NOTICE OF APPROVAL

Planning Case #: Design Study 23185

Project Description: Reduce existing eaves throughout, remove the east brow roof, lower roof line, partially remove the south rake and wood lintel over the entryway on the east façade, demo exterior crawl space access well, add two (2) corbels to support south rake of primary suite and wood shutters at upstairs east windows, site coverage and new landscape work, and install a 24 kw gas backup generator in "Zombiebox" in the south yard

Permit #: DS 23-185 (Homrig) (revised DS 22-029 (Homrig)

PROPOSED ROOF PLAN

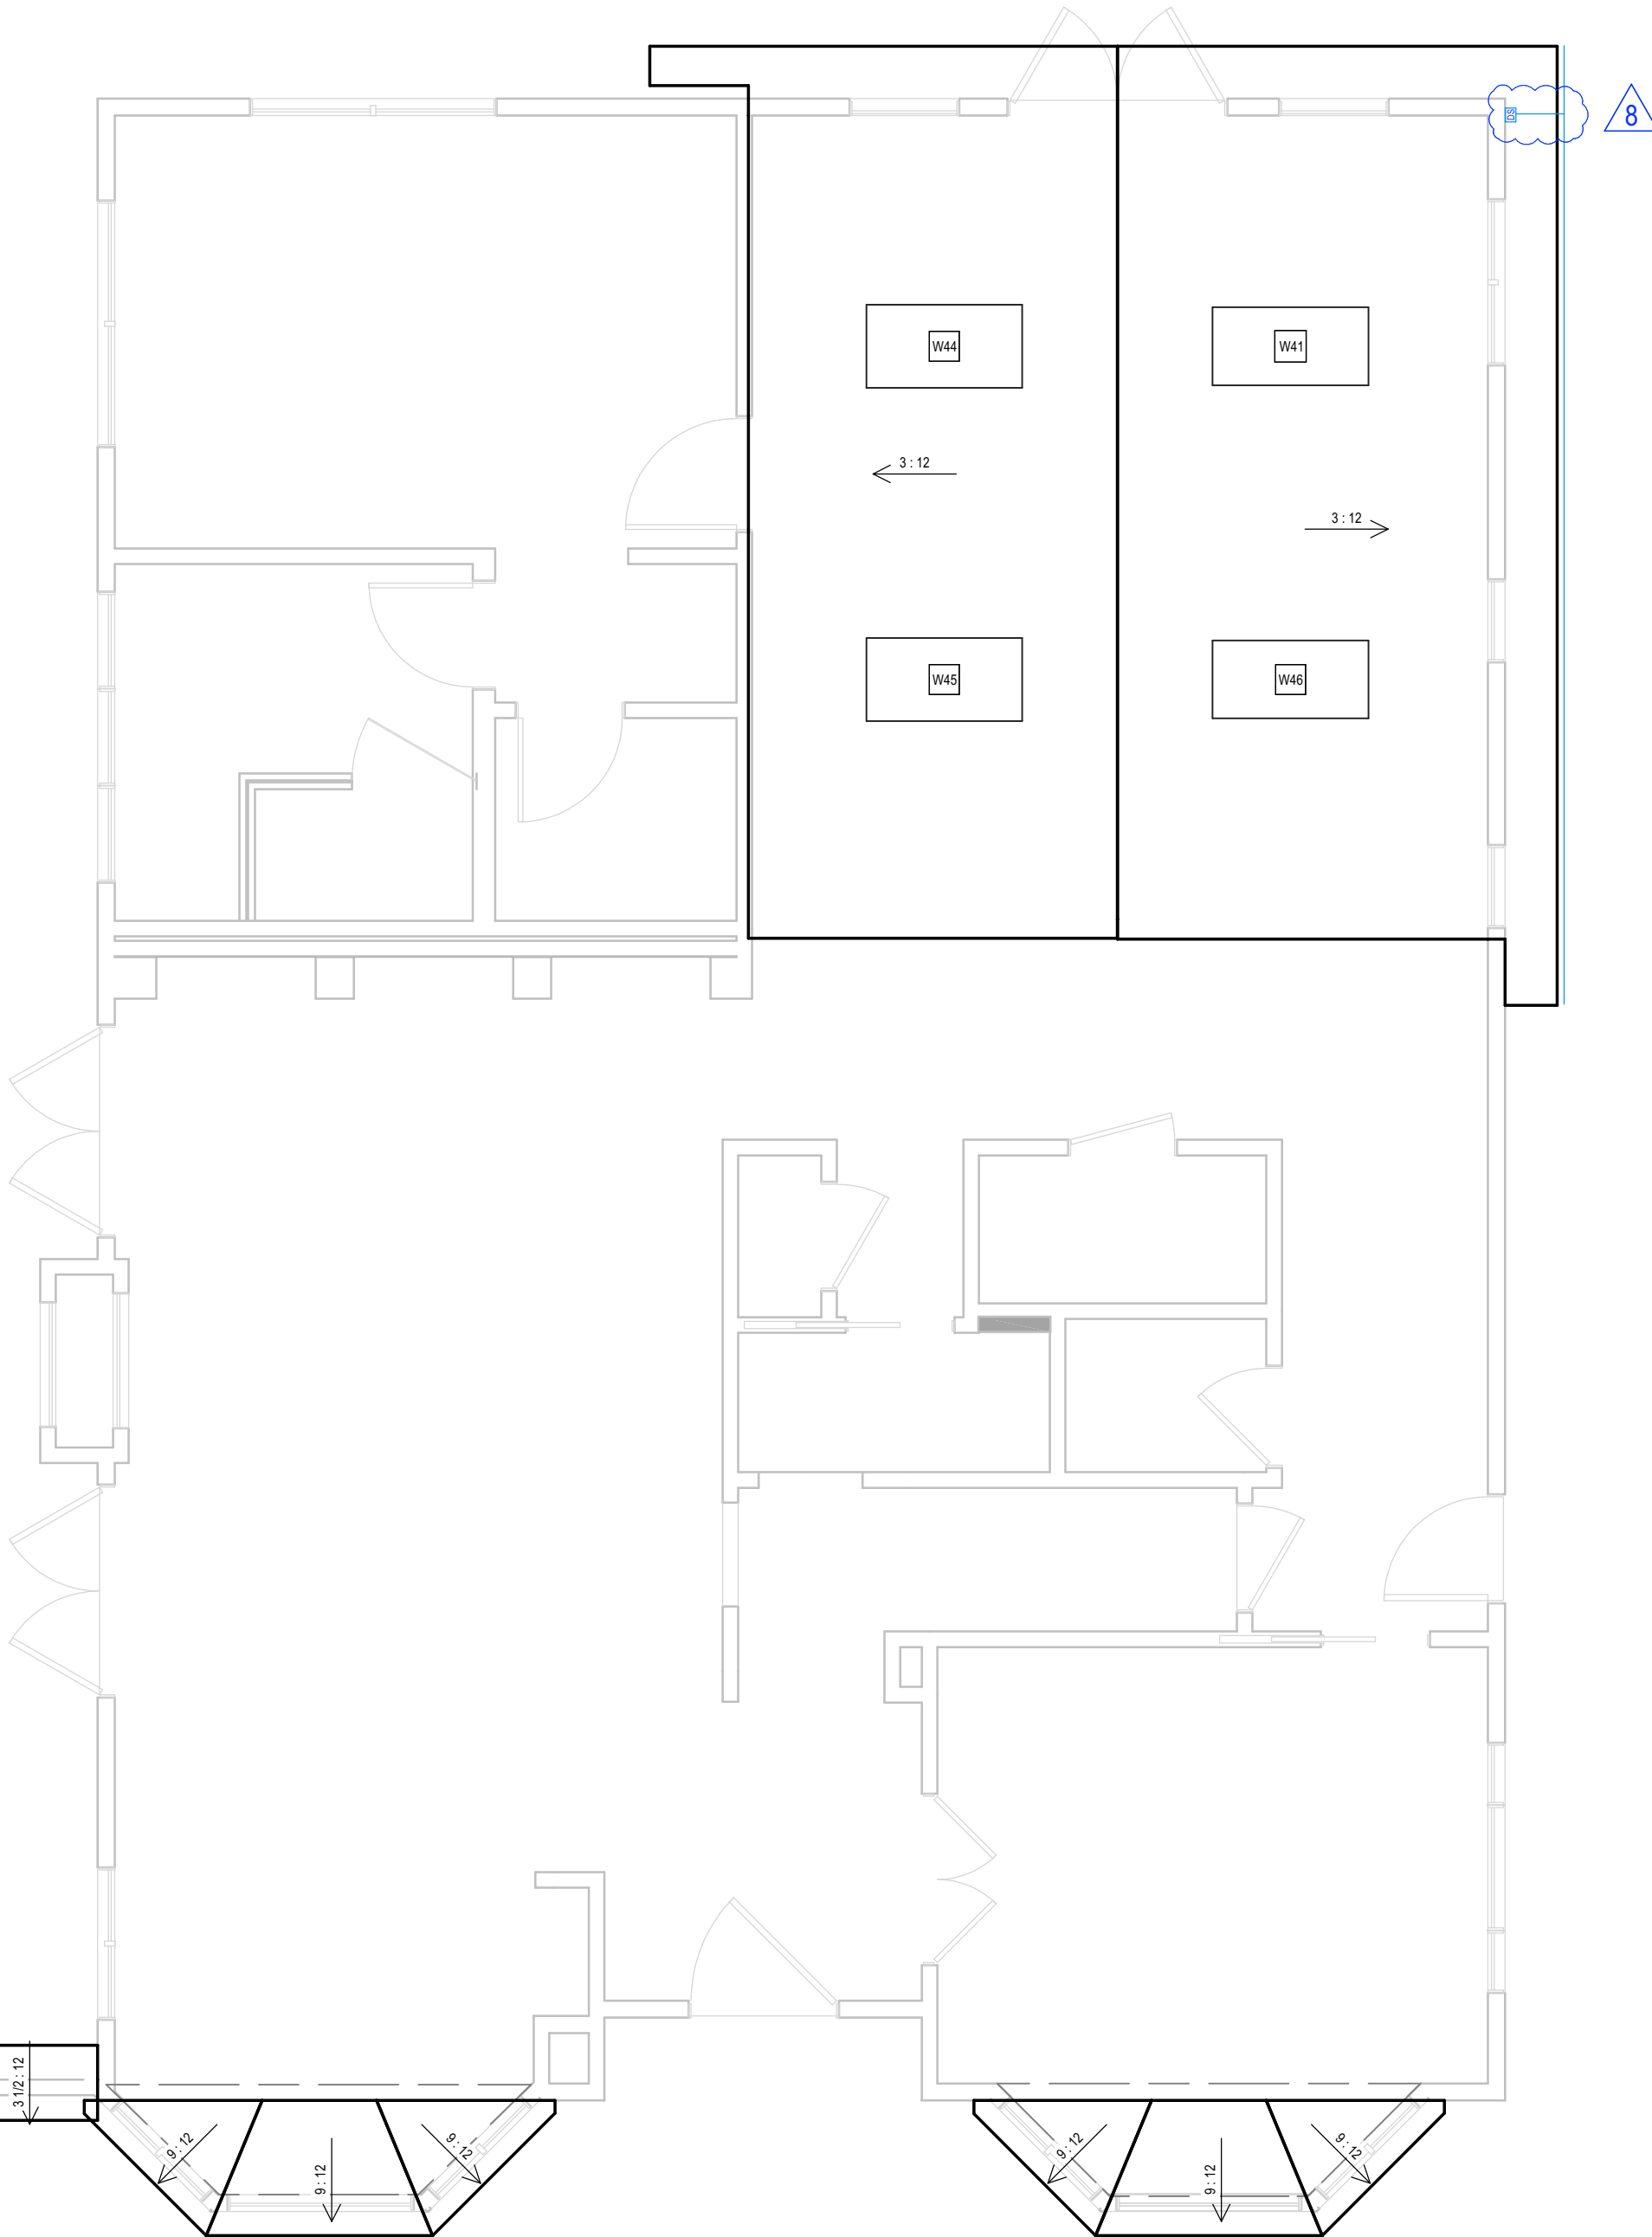
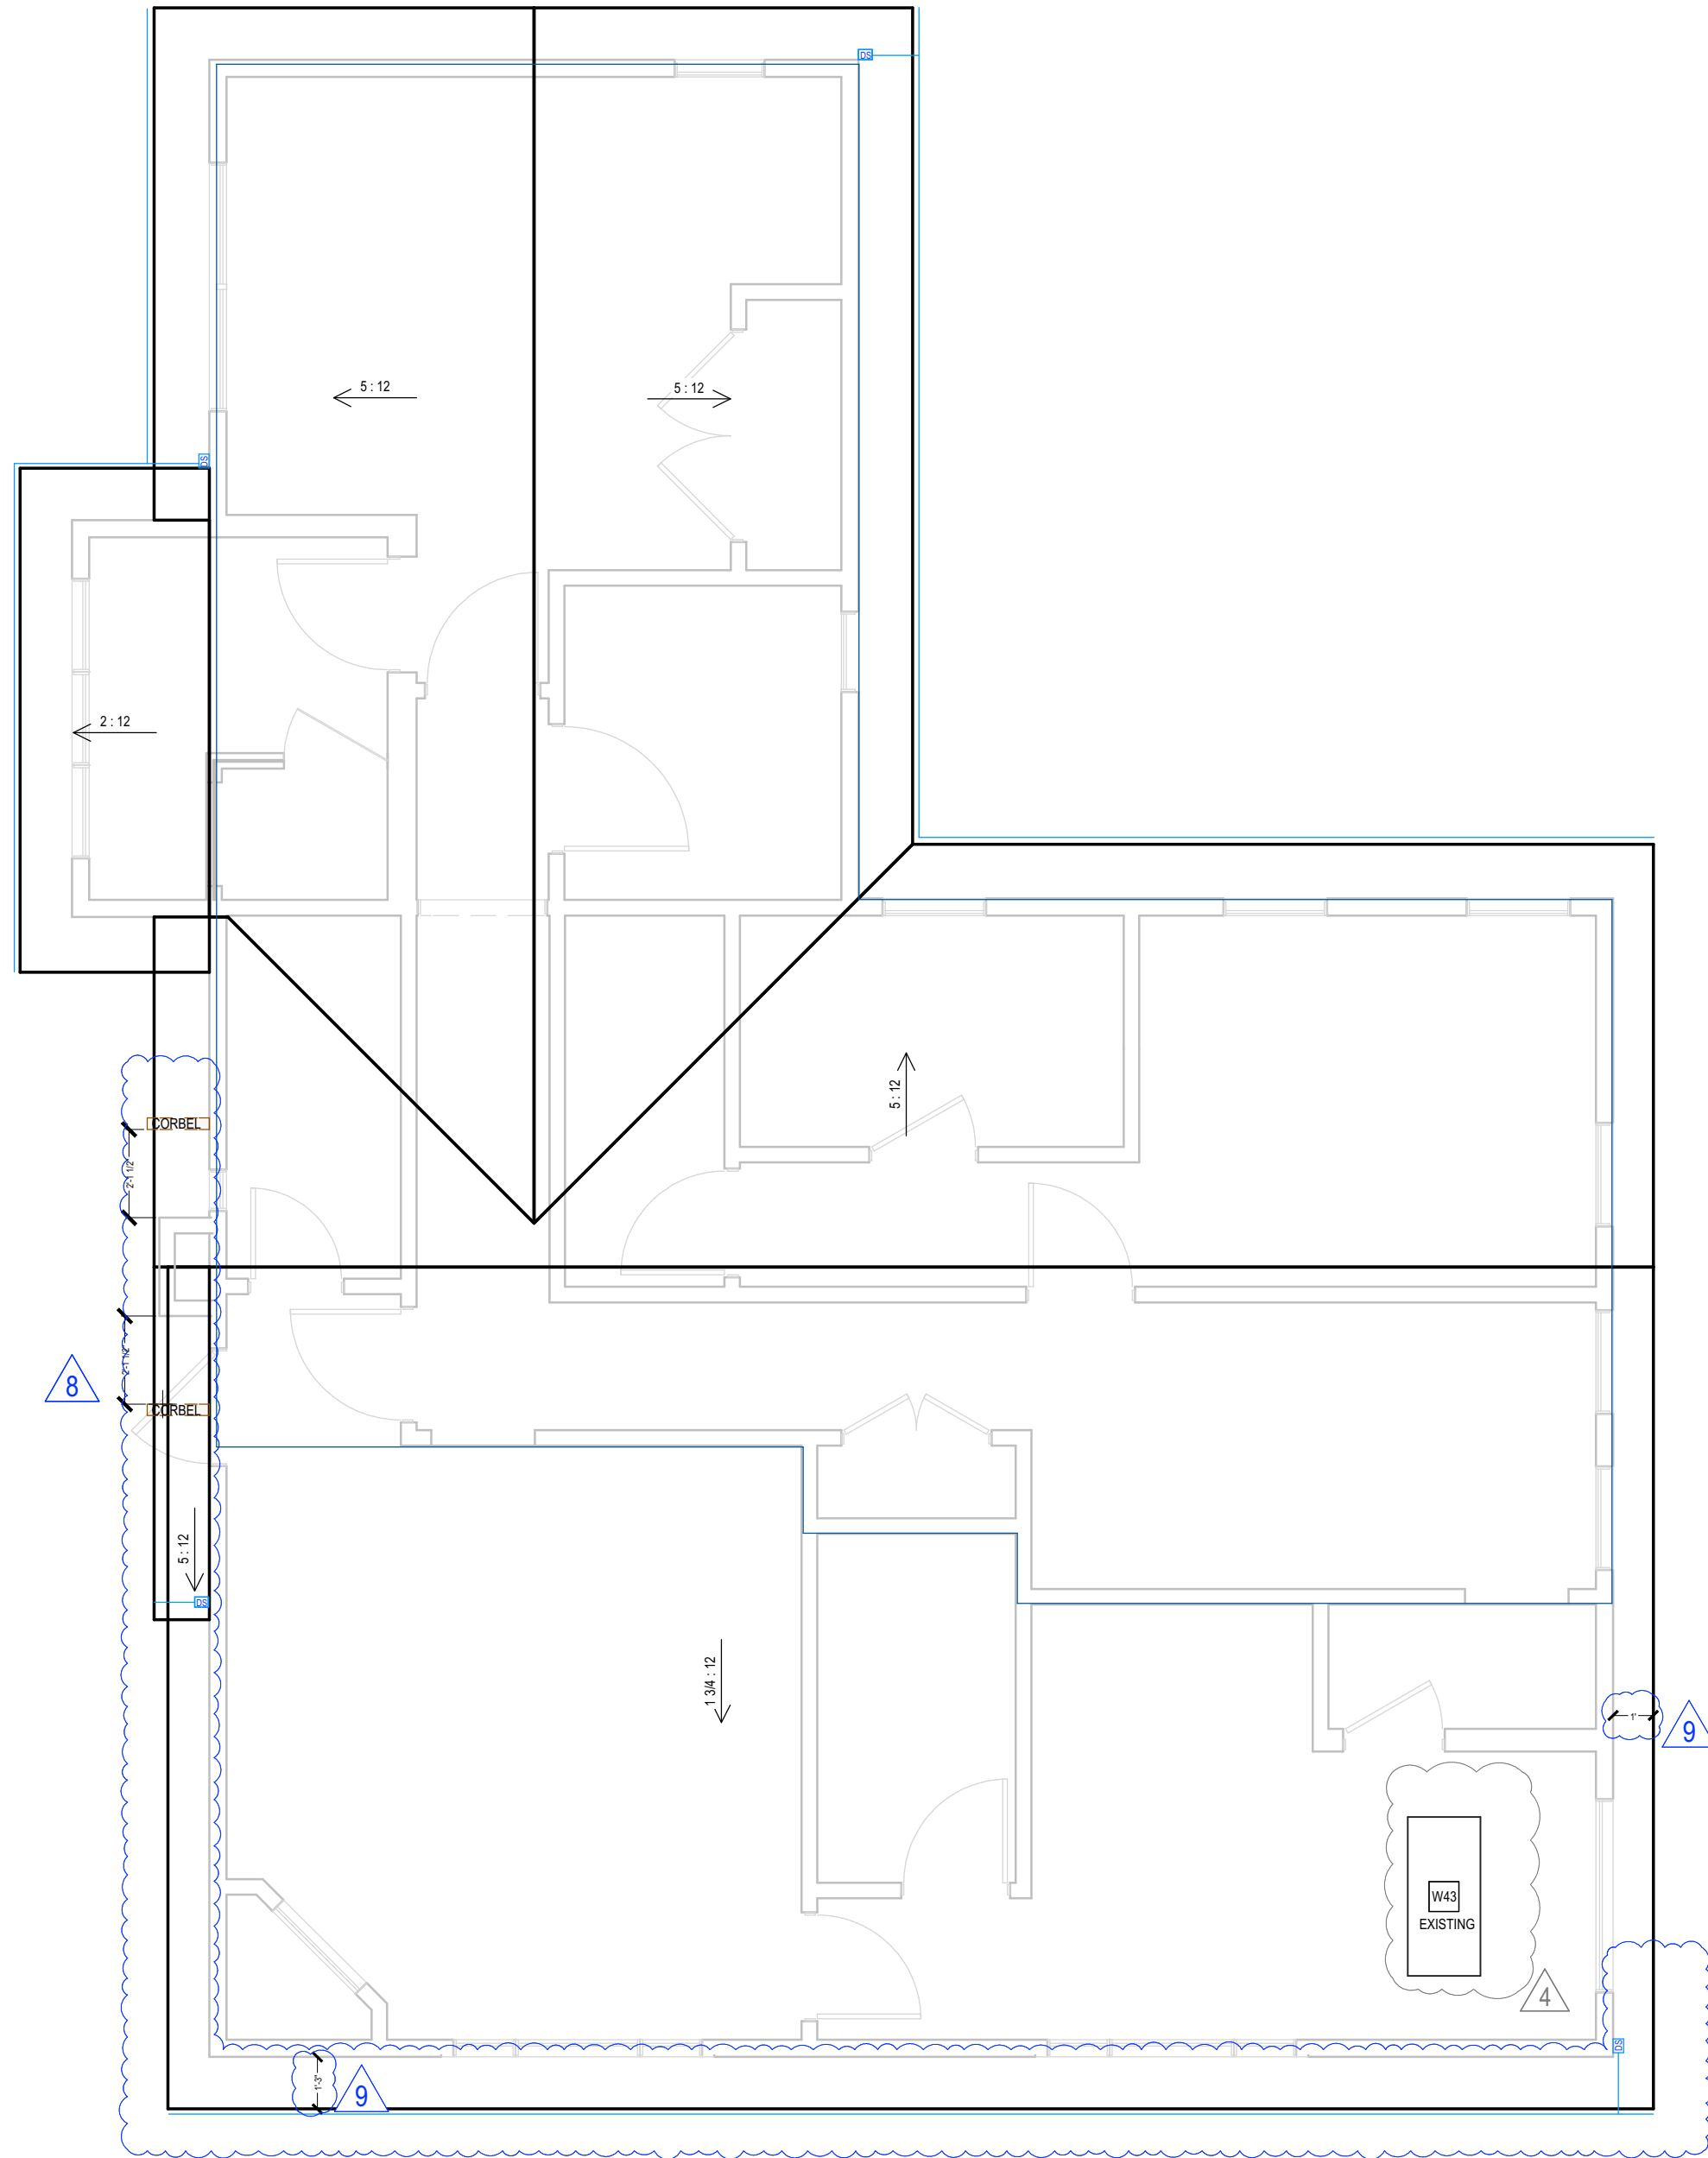
ALL ROOFING TO BE REMOVED AND REPLACED.
DEMO SKYLIGHTS IN PRIMARY BATHROOM.
REPLACE SKYLIGHTS IN DINING ROOM.

CUT BACK ALL EAVES& RAKES, EXCEPTING GARAGE AND NORTH & SOUTH RAKES OF EAST FACING SECOND FLOOR SHED ROOF ON PRIMARY SUITE. SEE DETAILS ON SHEET A-6.3 FOR EAVE & RAKE DEPTHS.
LOWER BROW ROOF ON EAST FACADE REMOVED

PROPOSED ELEVATION - EAST (STREET VIEW)

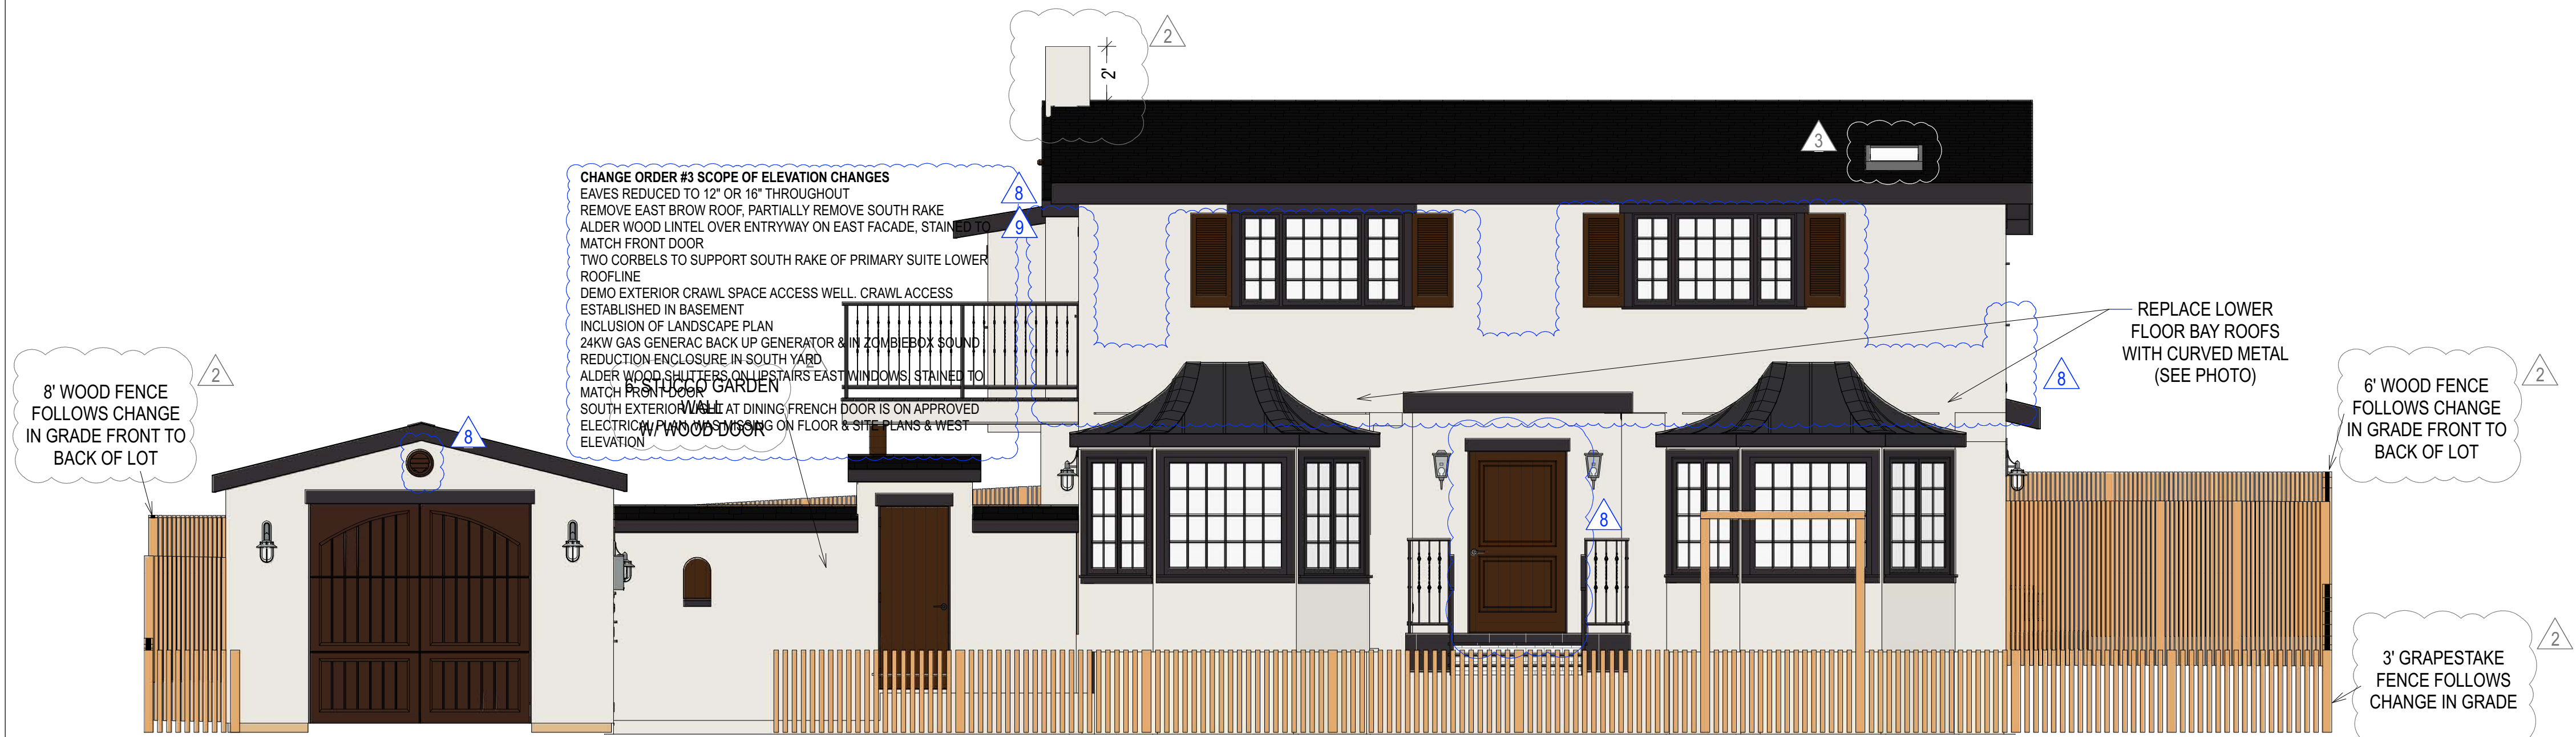
CHANGE ORDER #3 SCOPE OF ELEVATION CHANGES
EAVES REDUCED TO 12" OR 16" THROUGHOUT
REMOVE EAST BROW ROOF, PARTIALLY REMOVE SOUTH RAKE
ALDER WOOD LINTEL OVER ENTRYWAY ON EAST FACADE, STAINED TO MATCH FRONT DOOR
TWO CORBELS TO SUPPORT SOUTH RAKE OF PRIMARY SUITE LOWER ROOFLINE
DEMO EXTERIOR CRAWL SPACE ACCESS WELL, CRAWL ACCESS ESTABLISHED IN BASEMENT
INCLUSION OF LANDSCAPE PLAN
24KW GAS GENERATOR BACK UP GENERATOR 8 IN COMBIBOX SOUND REDUCTION ENCLOSURE IN SOUTH YARD
ALDER WOOD SHUTTERS ON UPSTAIRS EAST WINDOWS, STAINED TO MATCH FRONT DOOR
SOUTH EXTERIOR WALL AT DINING/FRENCH DOOR IS ON APPROVED ELECOTRICIAN WALL HANGING ON FLOOR & SITE PLANS & WEST ELEVATION
ROUND GABLE VENT ON GARAGE, STAINED TO MATCH FRONT DOOR

CUT BACK ALL EAVES & RAKES, EXCEPTING GARAGE AND NORTH & SOUTH RAKES OF EAST FACING SECOND FLOOR SHED ROOF ON PRIMARY SUITE. SEE DETAILS ON SHEET A-6.3 FOR EAVE & RAKE DEPTHS.
LOWER BROW ROOF ON EAST FACADE REMOVED

EXTERIOR ELEVATIONS - NORTH

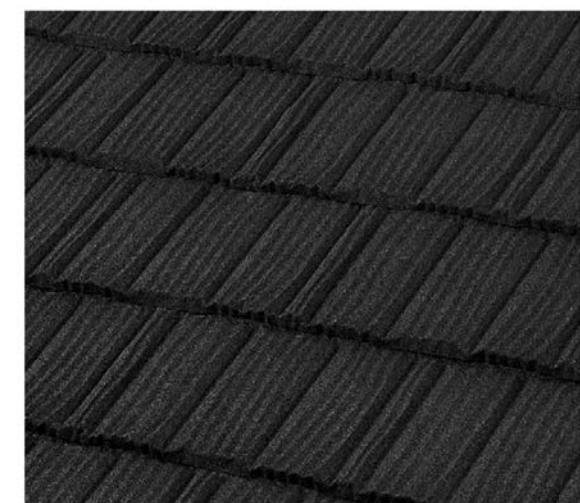
CHANGE ORDER #3 SCOPE OF ELEVATION CHANGES
EAVES REDUCED TO 12" OR 16" THROUGHOUT
REMOVE EAST BROW ROOF
WOOD ATTIC VENT IN SOUTH AND NORTH GABLES, STAIN TO MATCH FRONT DOOR
